WHITE LAKE CHARTER TOWNSHIP
COMMUNITY DEVELOPMENT DEPARTMENT
PLANNING COMMISSION – SUPPLEMENTAL STAFF REPORT

Property: 8320 Highland Road – BP Gas Station

Request: Special Land Use – Expansion of Existing Automobile Service Station

Proposal: Installation of four (4) dedicated EV charging spaces served by two (2) DC fast chargers and associated electrical equipment

ENLARGED SITE PLAN

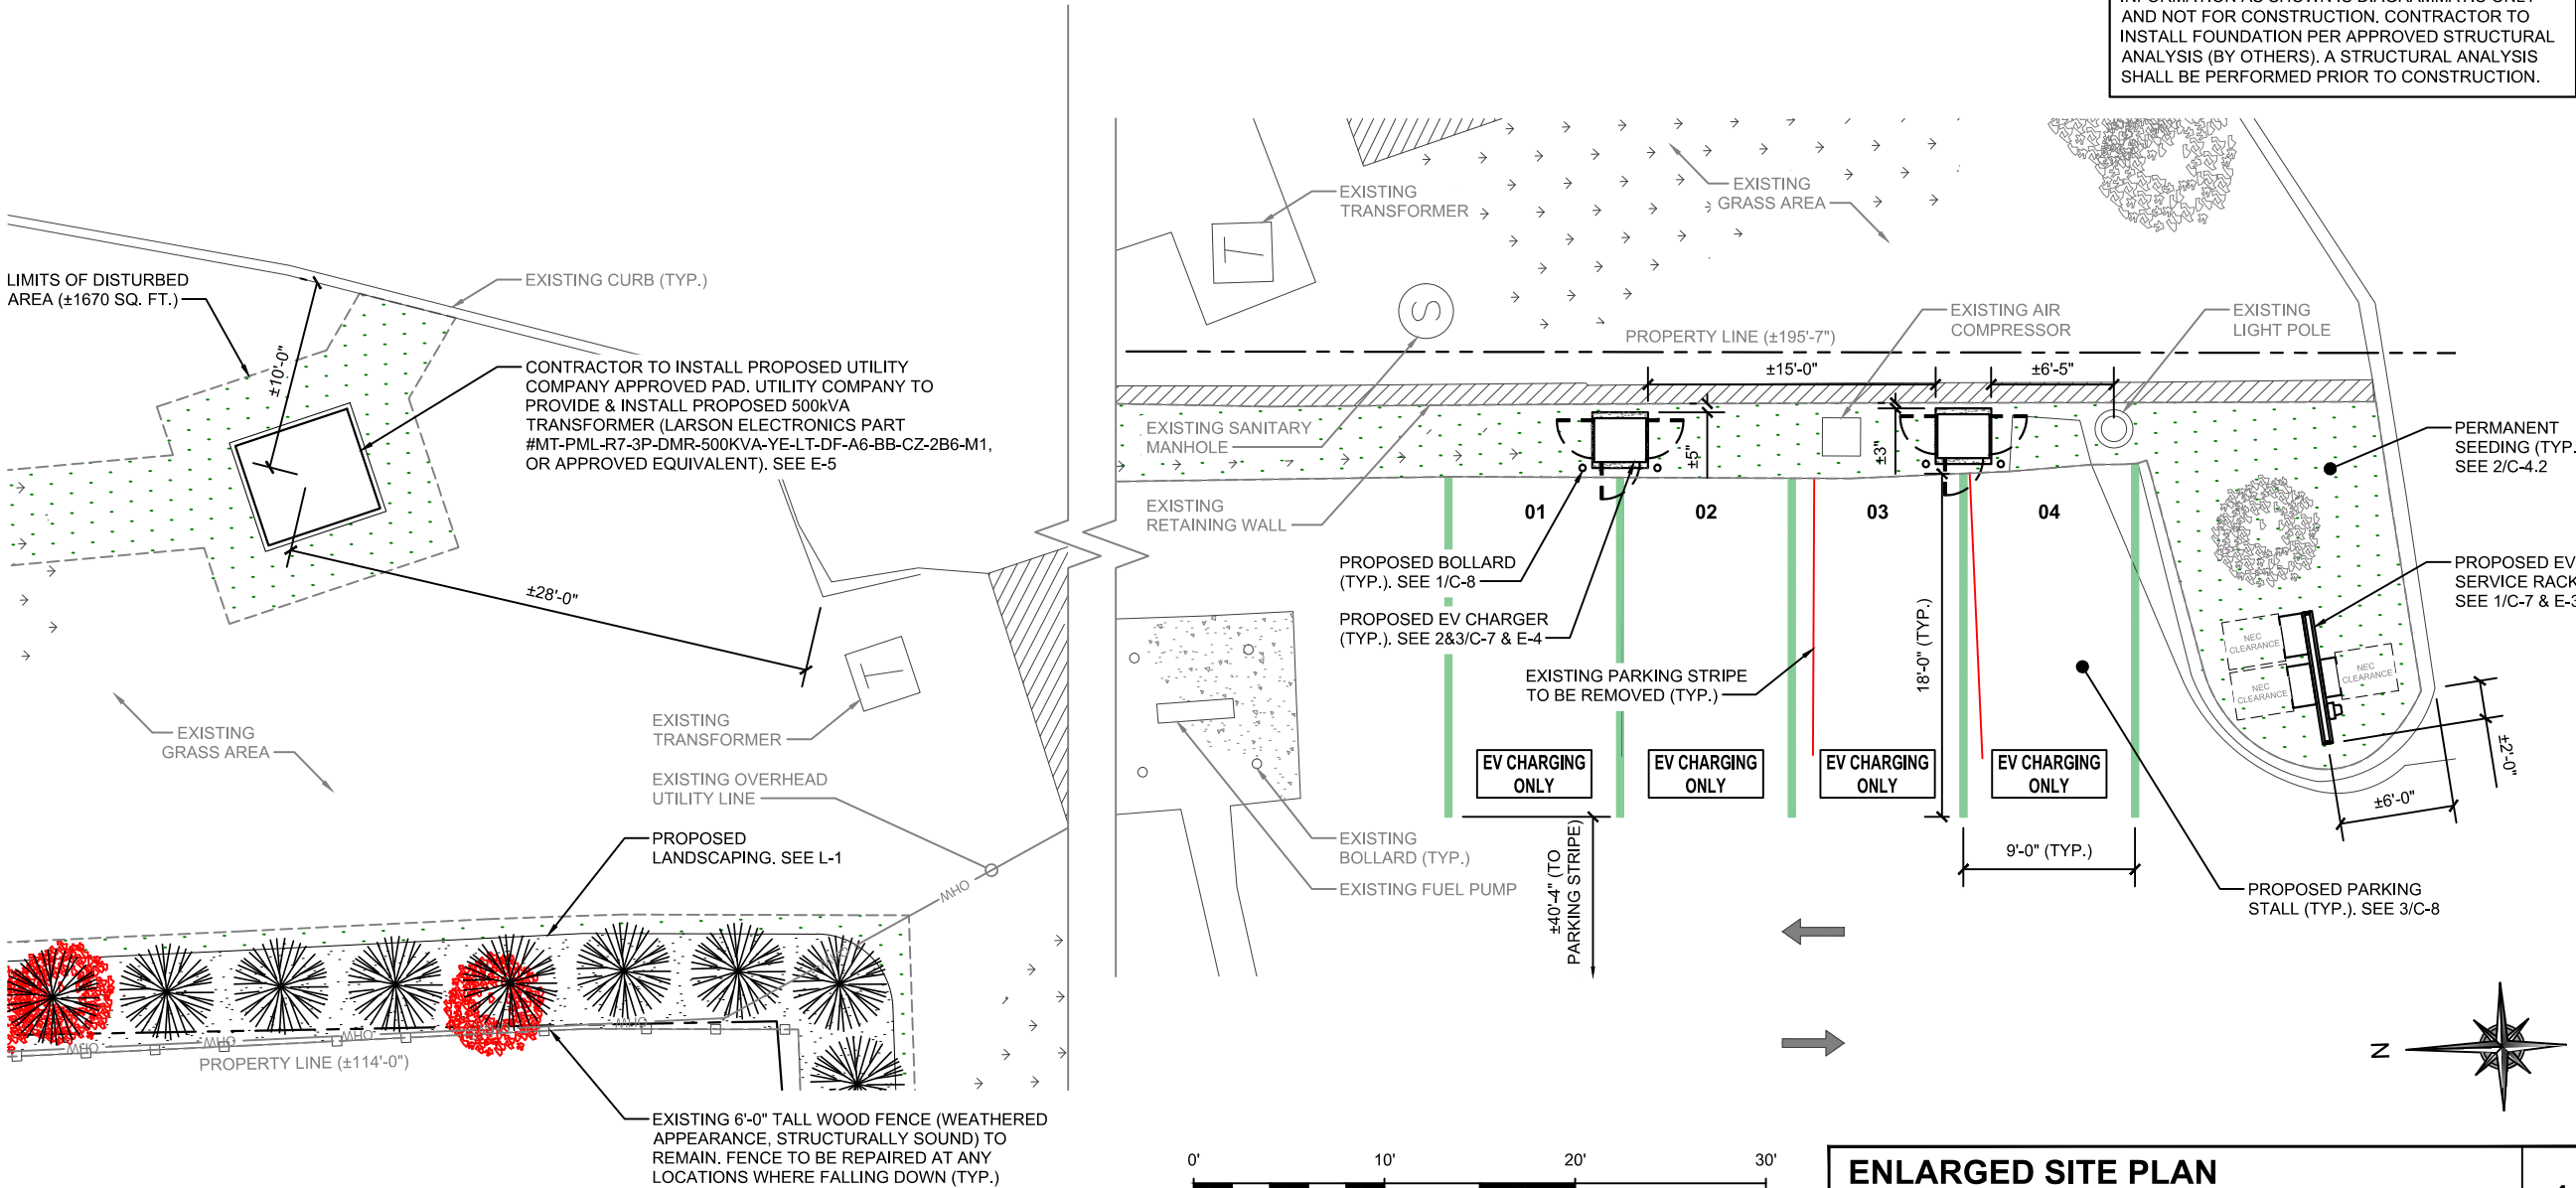
More importantly, Revision 4 substantially changes the physical circumstances that led to the August noise concerns. The charging equipment has been relocated away from the residential interface to approximately 115 feet from the residential property line. **Staff considers this a substantial improvement over the August layout and a meaningful response to the Commission's direction to study alternate charger locations.**

Using the same sound-distance methodology contained in the applicant's August plans, a 65 dBA charger source would be approximately **34 dBA at 115 feet**. If both charger cabinets are conservatively assumed to operate simultaneously at this level, together with the transformer sound identified in the applicant's plans, the combined sound level is estimated at approximately **38 dBA at the residential property line**. This is approximately **7 dBA below the Township's 45 dBA nighttime standard**.

During review of the resubmittal, staff located a recorded utility easement affecting the property that was not depicted on the August plans. The easement contains an existing **12-inch Township water main**.

The revised plans should depict the boundaries of the **recorded easement itself** so that the relationship between the proposed equipment and the Township's utility rights can be evaluated.

Staff has also requested that **all known easements affecting the property** be depicted on the revised plan. The applicant and its surveyor are responsible for accurately identifying known easements affecting the proposed improvements rather than relying solely upon easements that may be located in Township historical records.

Because the identified easement contains a Township water main, the proposed equipment location is also subject to DPW review to ensure that the improvements do not interfere with the utility or the Township's ability to access and maintain it.

LANDSCAPING PLAN

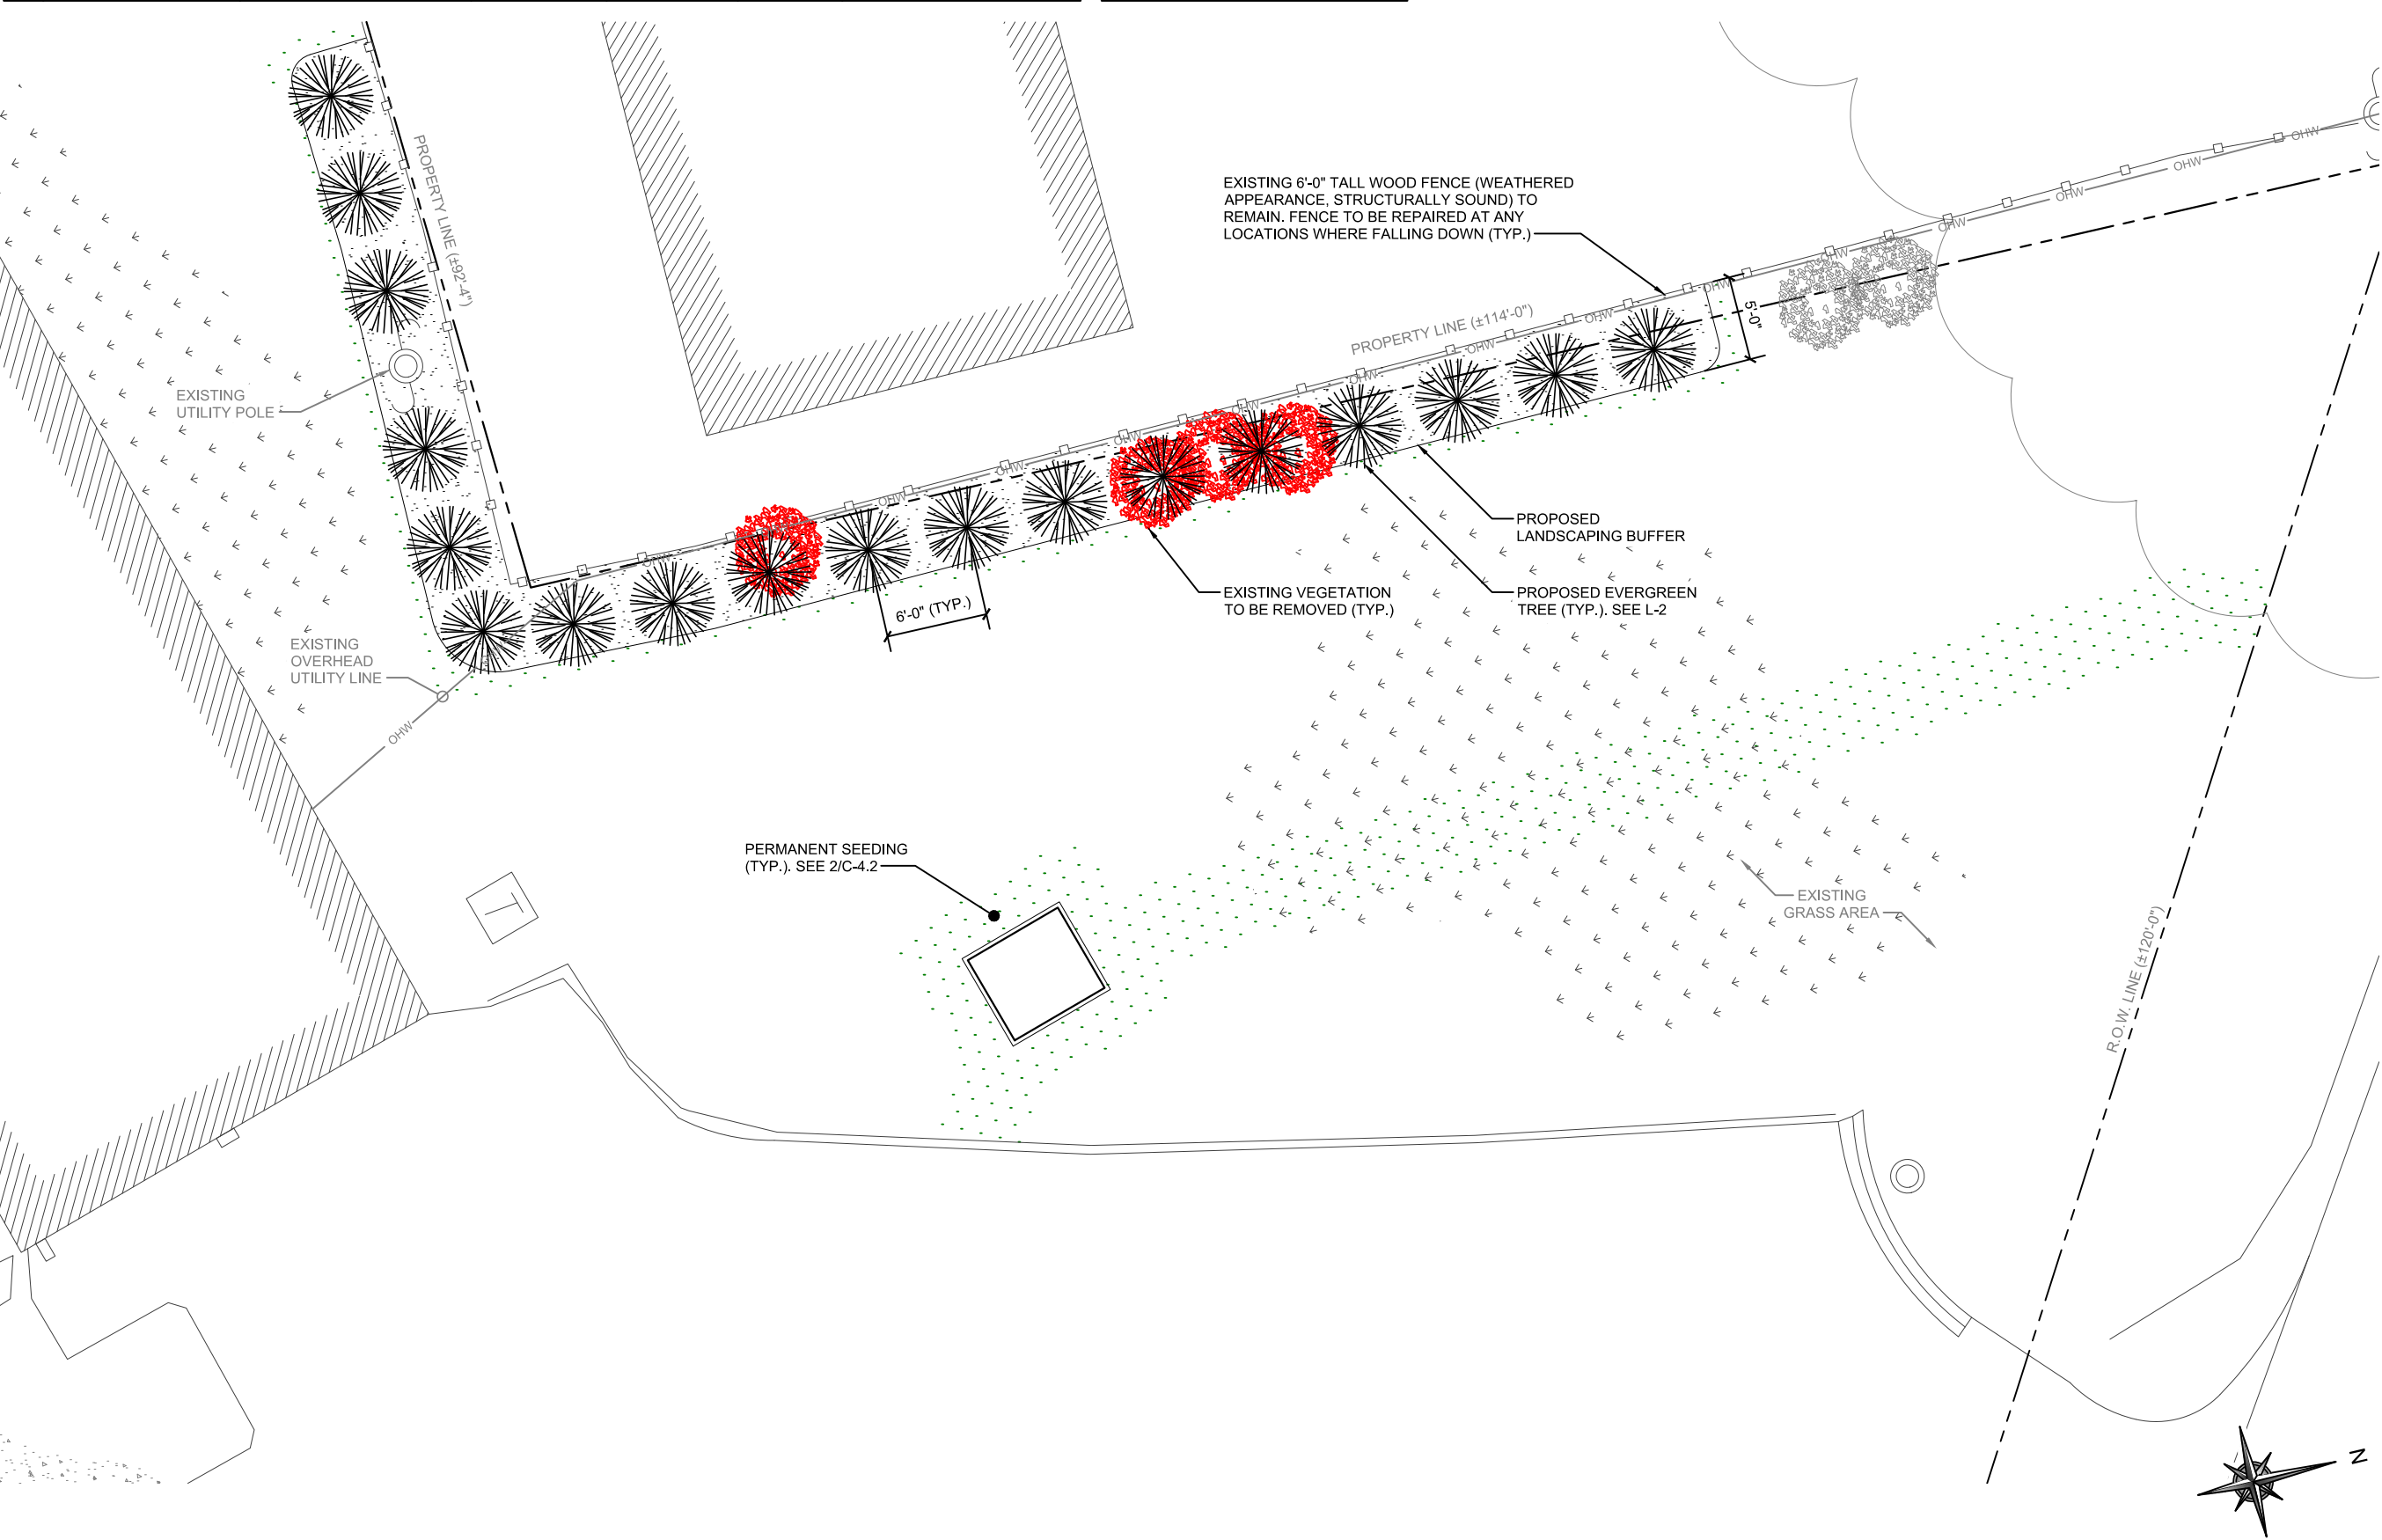
However, the Commission's current direction was specifically to improve the landscaping and buffering along the residential property line, and as of the date of this report, they have not yet shown that on the proposed plan.

Staff has advised the applicant that a **new, high-quality screening fence supplemented by additional landscaping along the full residential property line** would more clearly respond to the Commission's direction than limited repairs to deteriorated portions of the existing fence.

Existing Lighting near EV
chargers

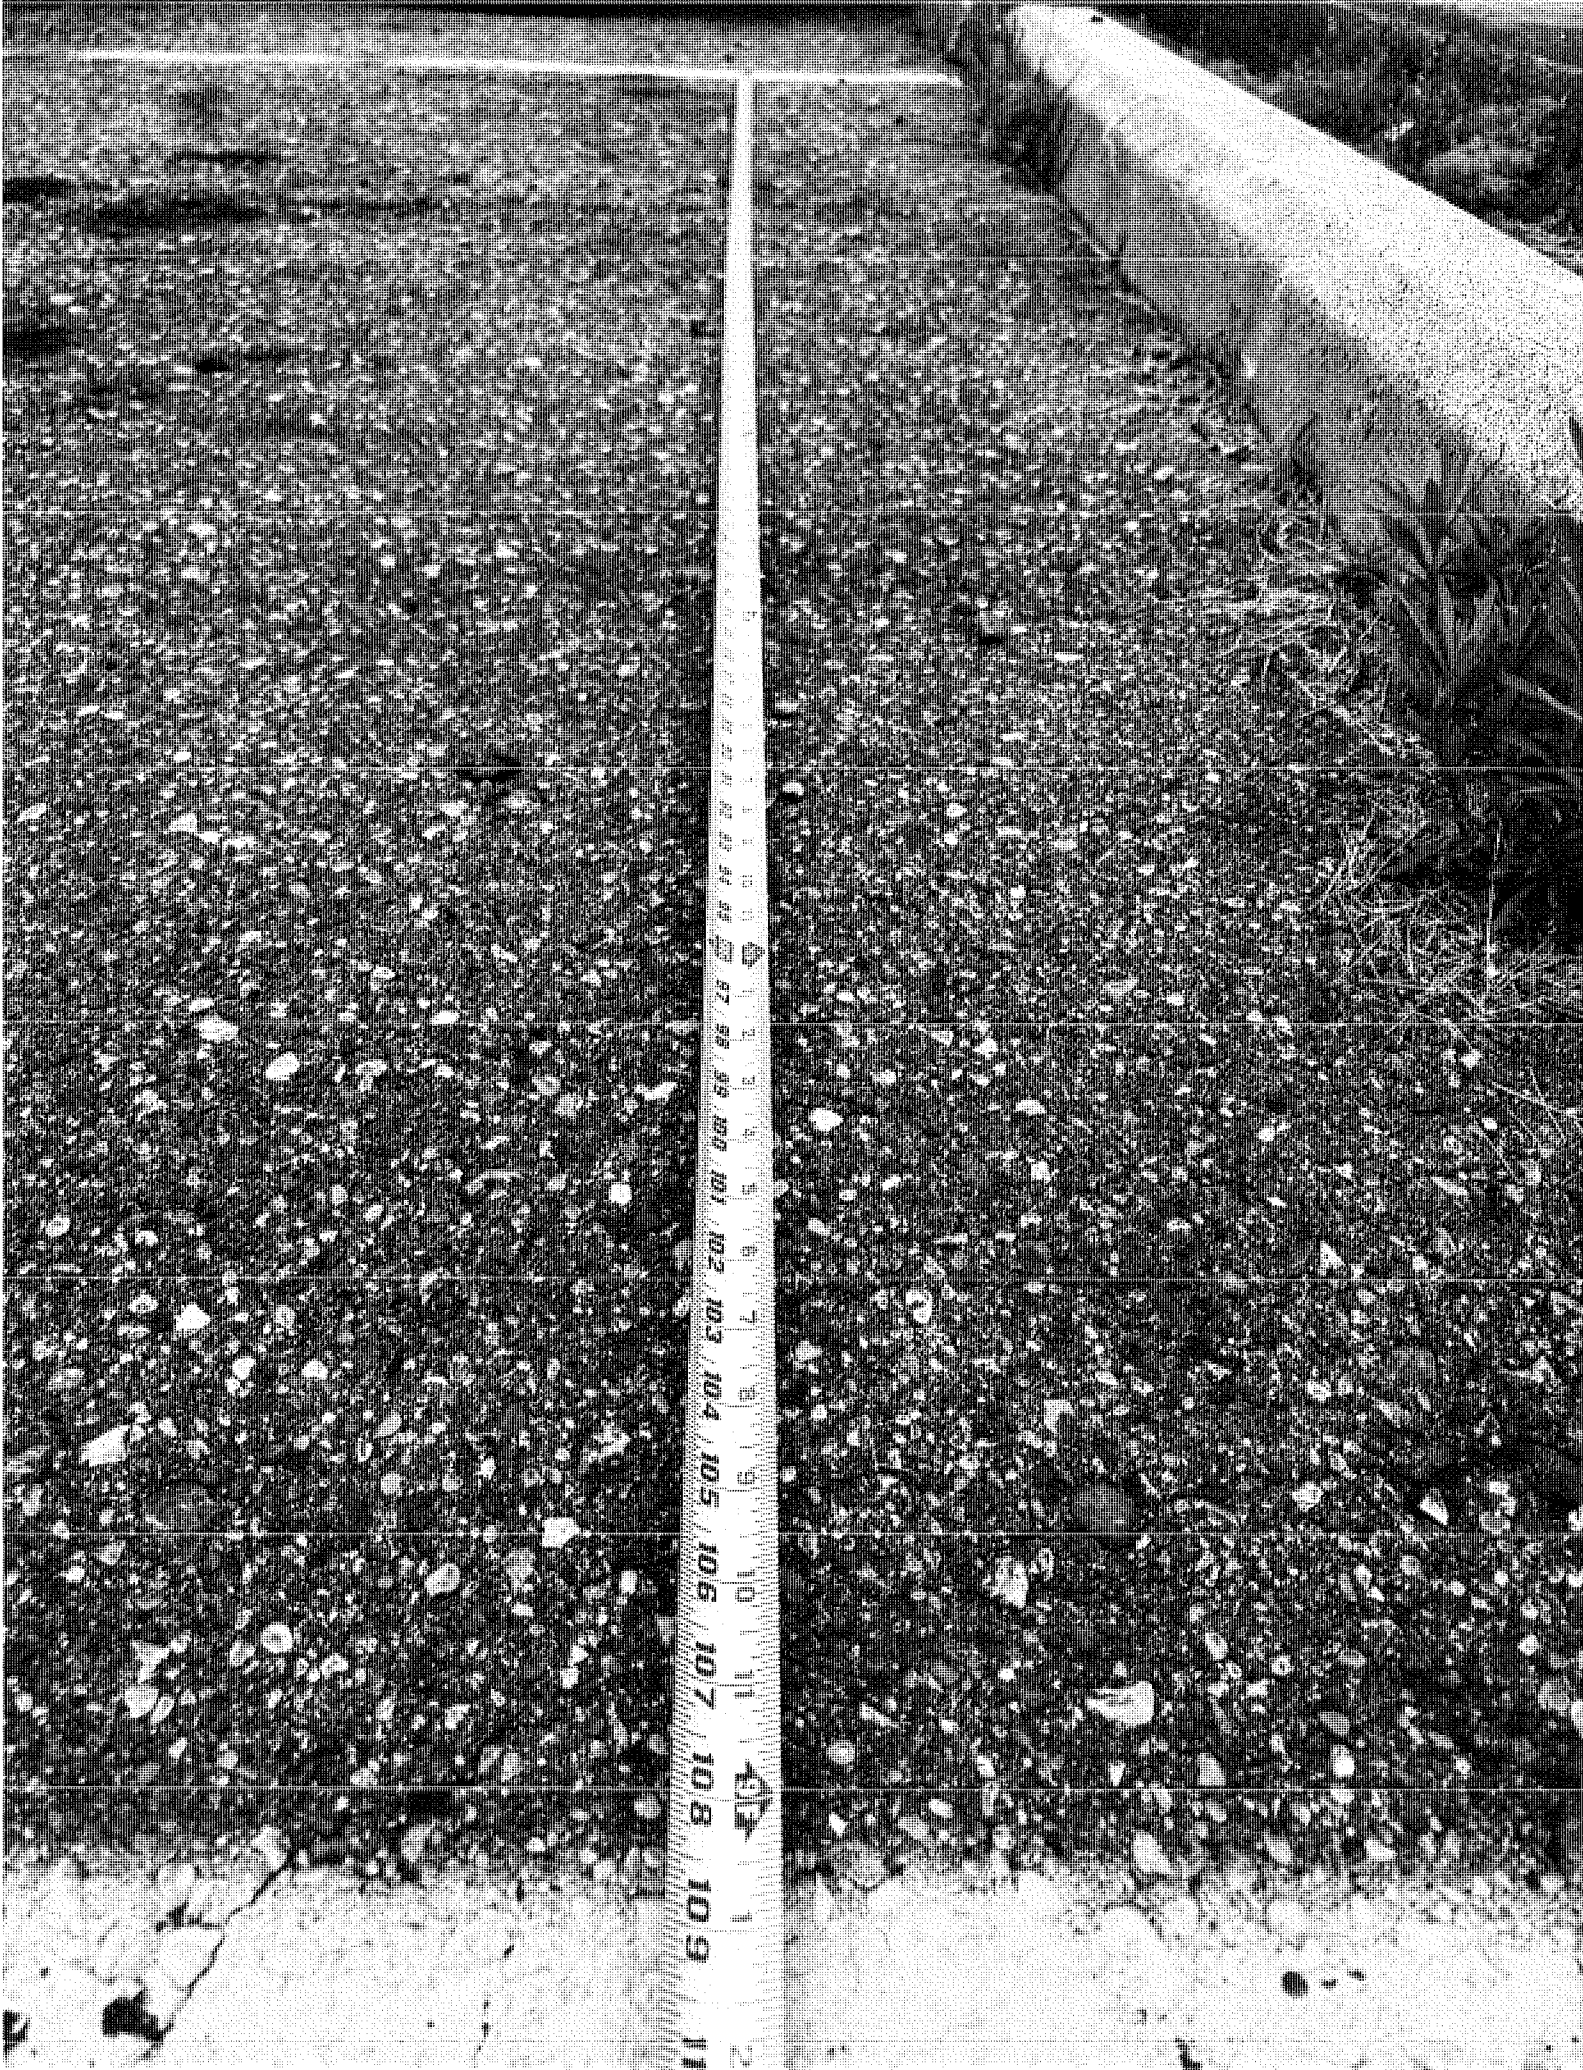
The plans also propose new wall-mounted lighting associated with the EV charging area. Staff is comfortable with the use of fully shielded, downward-directed wall-mounted fixtures, provided the fixtures are designed and installed so that light is confined to the subject property and does not create glare or spillover onto adjoining residential property or public rights-of-way.
